ALERT SERVICE BULLETIN

SUBJECT: **REVISION "A" TO ALERT SERVICE BULLETIN 206-01-96: (CHIP
DETECTOR ASSEMBLY, TEDECO B3188B**

NO. 206-01-96

SUBJECT: CHIP DETECTOR ASSEMBLY, TEDECO B3188B

FIGURE 1

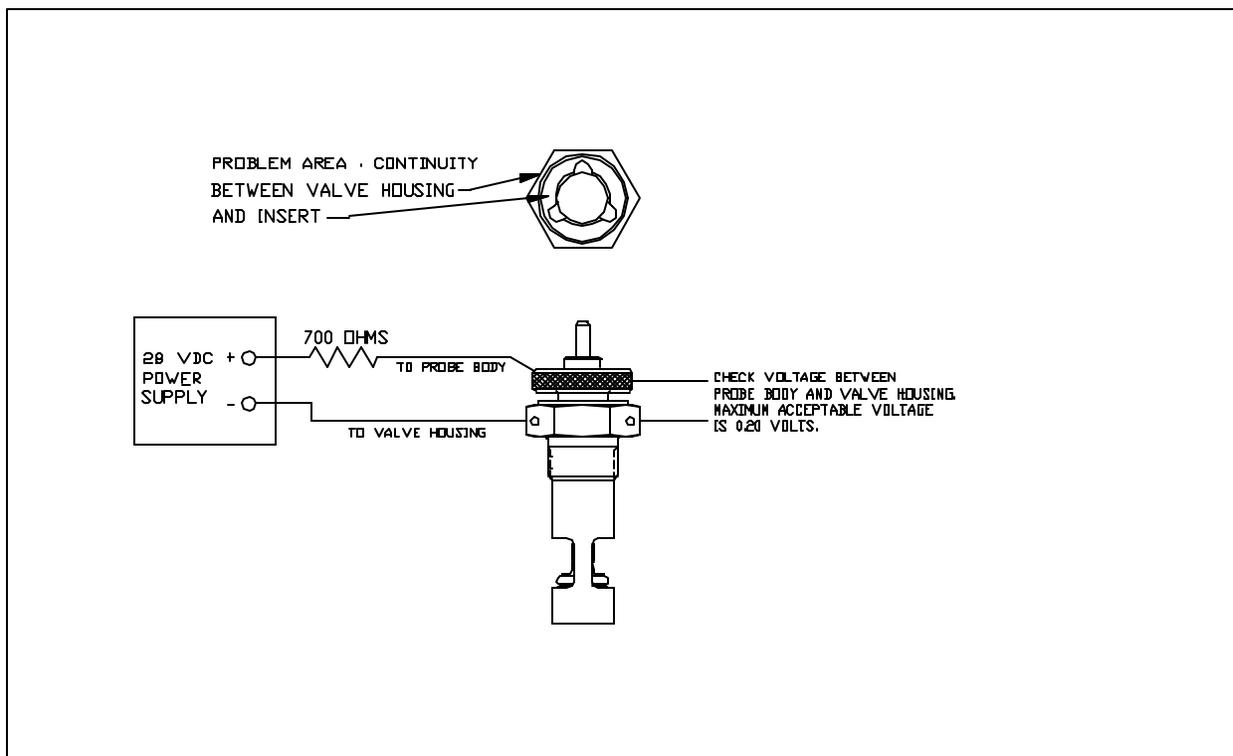
1. Connect the chip detector to a 28 Volt DC power supply using a 700 ohm, 2 watt resistor as shown in Figure 1.
2. Measure the voltage between the probe body and the valve body. The voltage drop must be 0.20 volts or less across the unit. If the voltage drop is larger than 0.20 volts, then return the unit to Tedeco (See 3. Part Replacement.)

FIGURE 2

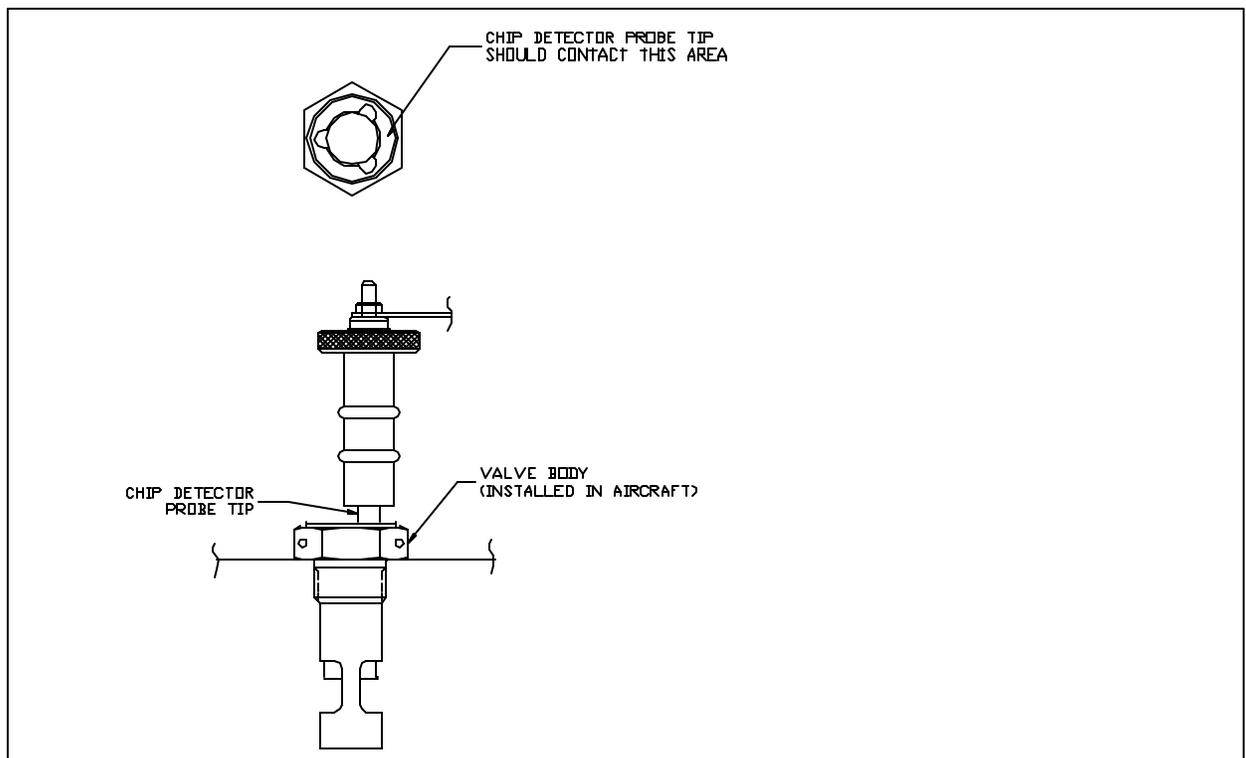
1. Ensure that electrical power is supplied to the chip detector.
2. Remove the chip detector probe from the self-closing valve.
3. Hold the tip of the center stud of the chip detector probe firmly against the steel insert as shown in Figure 2 while checking chip indicator light in cockpit. If the cockpit light illuminates, the unit is acceptable. If the light does not illuminate, then proceed to the next step.

FIGURE 3

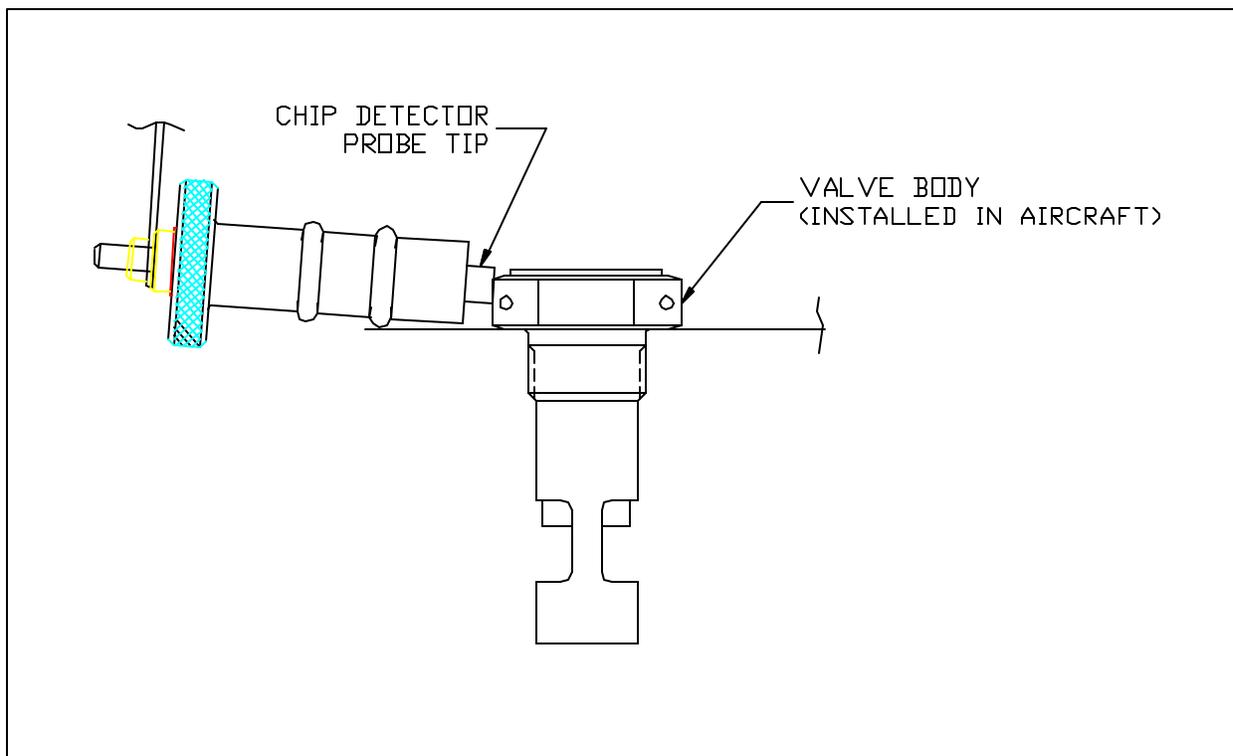
4. Hold the tip of the center stud of the chip detector probe firmly against the valve housing as shown in Figure 3 while checking chip indicator light in cockpit. The cockpit light should illuminate. Illumination of the light in this step isolates the electrical discontinuity to the valve insert. Repair the unit per the repair instructions in section 2 of this document.

FIGURE 4A

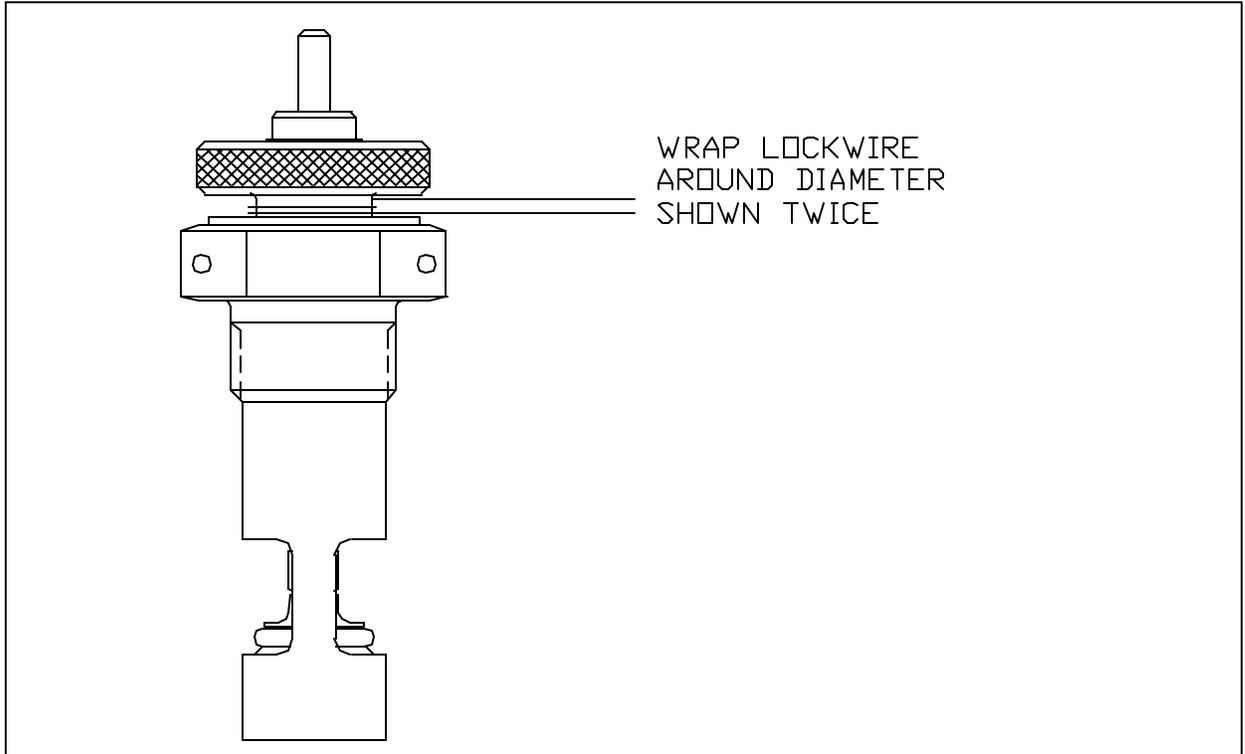
- 2.1. Install Chip Detector Probe into Valve assembly.
- 2.2. Tightly wrap a piece of lockwire (approx 6 inch length) around the chip detector probe diameter shown two full times. (See Figure 4A.)

FIGURE 4B

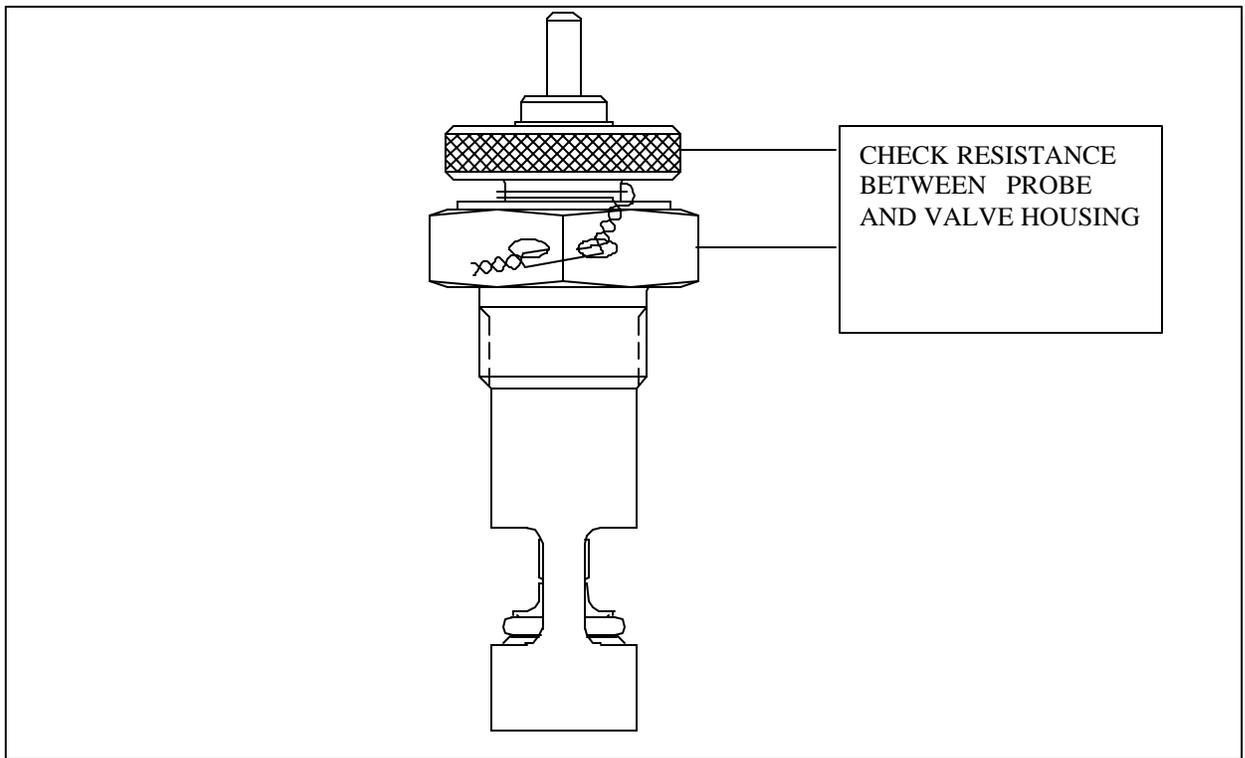
- 2.3. Twist two ends together approximately five times until twisted section reaches nearest free lockwire hole. Ensure that lockwire is tightly wrapped.
- 2.4. Slide one end of lockwire through the lockwire hole. Continue twisting two ends together to complete the lockwiring. (See Figure 4B.)
- 2.5. Check repair by using an ohmmeter to check resistance between the chip detector probe and the valve housing. Resistance should be 1 ohm maximum. (See Figure 4B.)
